BOULDER HILL SUBDIVISION - SANITARY SEWER REPLACEMENT AND SPOT REPAIRS CONTRACT 3-2024 *(Base Bid)*

**Fox Metro Water Reclamation District
Boulder Hill Subdivision – Sanitary Sewer Replacement and Spot Repairs**

ADDENDUM NO.1

March 8, 2024

1 OVERALL SUGGESTED DETOUR PLAN
SCALE: 1"=500'

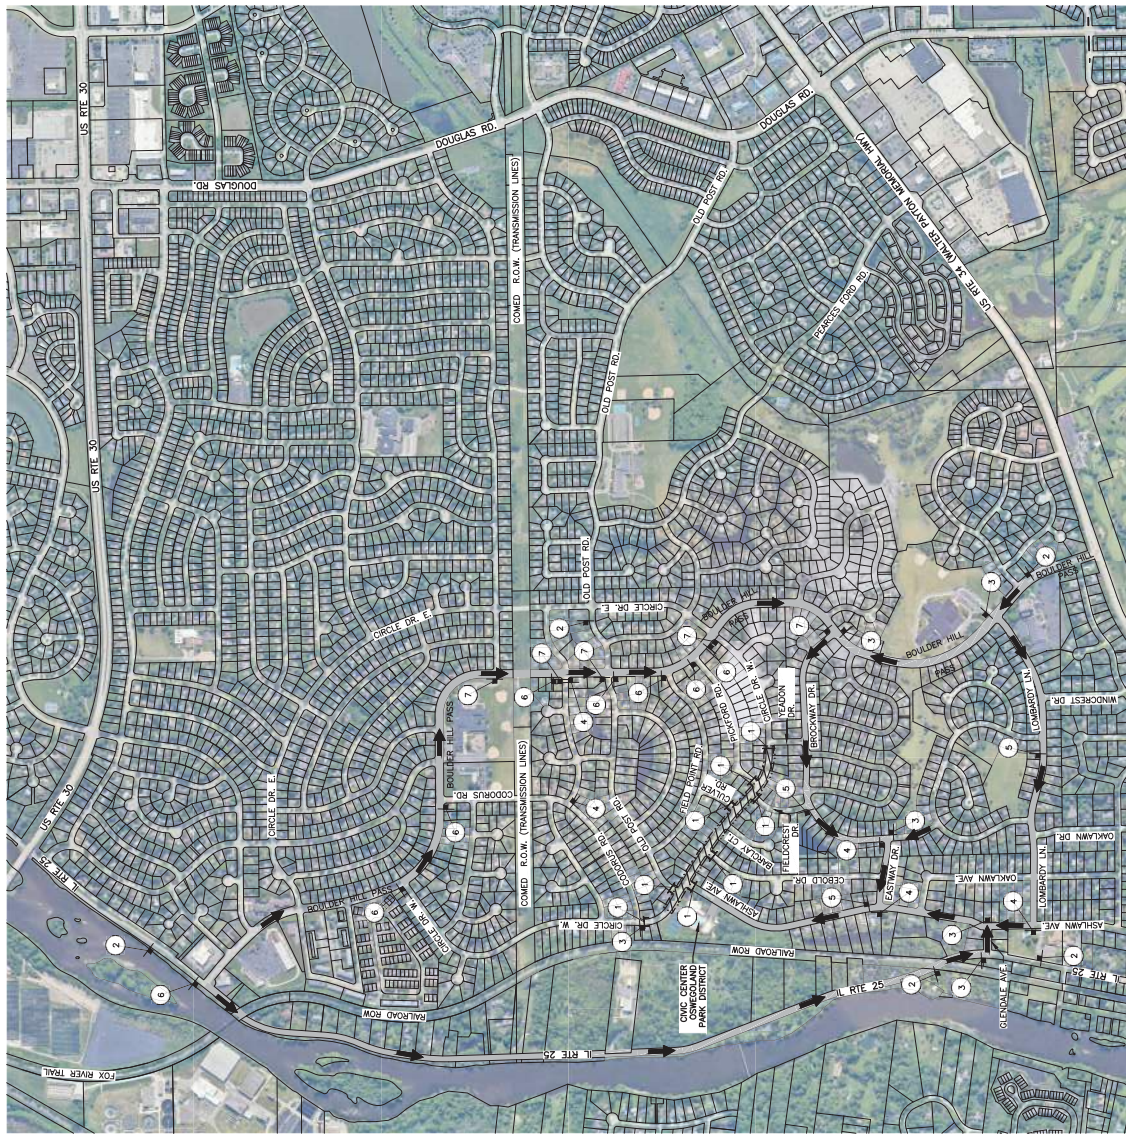
- Include revised date per Addendum No 1.
 - Revised Schedule of Quantities tables as shown.
- Sheet 09A and 09B: Overall Suggested Detour Plan:
 - Revised/Included the signage near the intersection of Codorus Rd and Circle Dr. W.

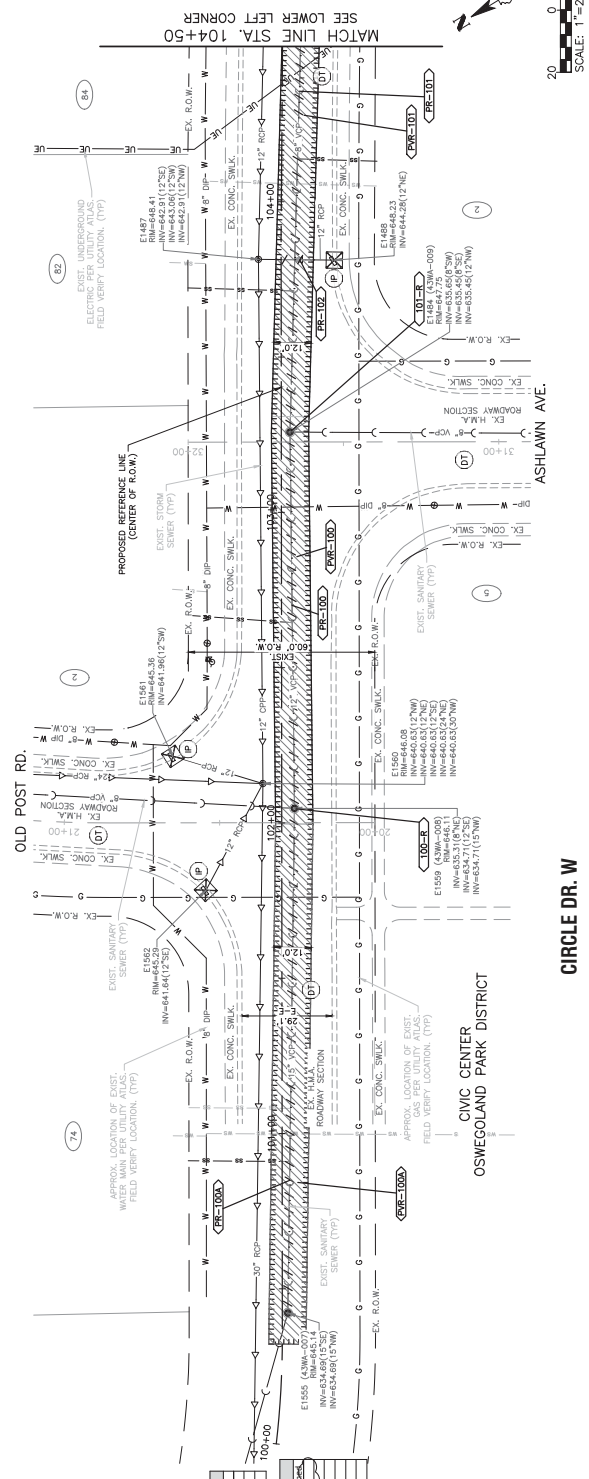
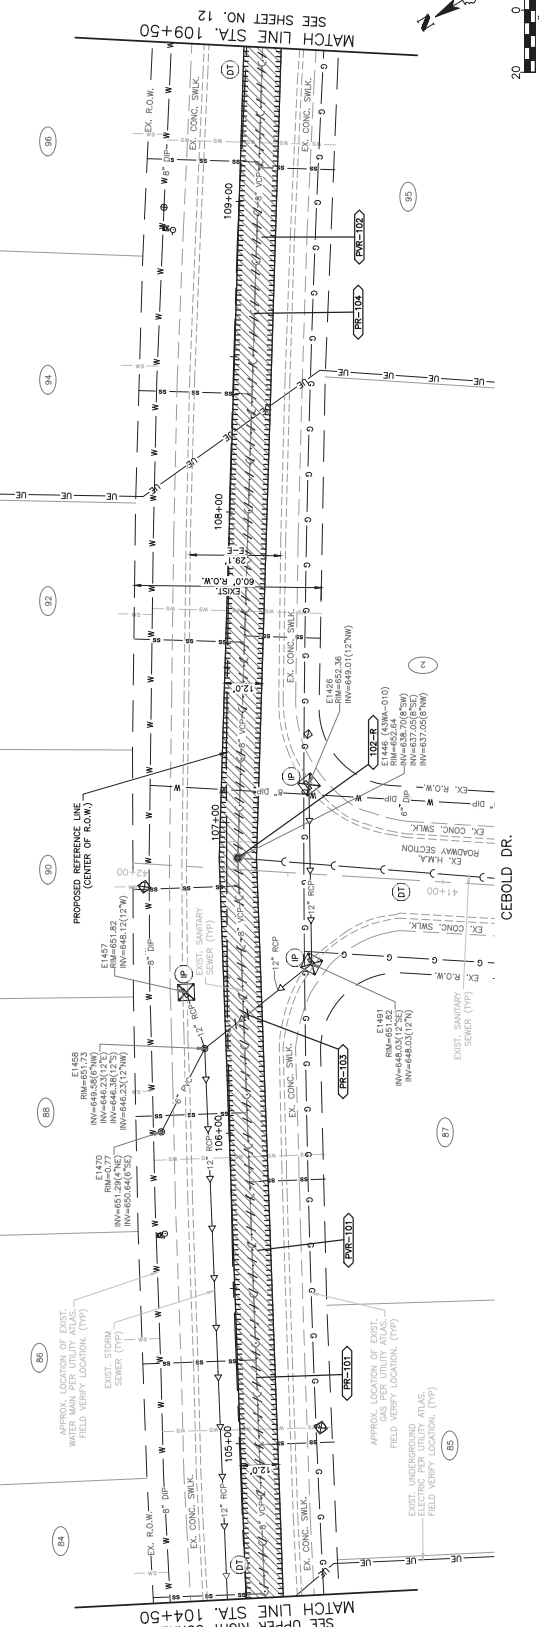
- Sheet 11: Existing Conditions, Erosion Control & Demolition Plan (Cricle Dr. W.):
 - Include revised date per Addendum No 1.
 - Revised entire sheet to include the existing 15” sanitary sewer replacement and pavement, see tags PR-100A and PVR-100A.
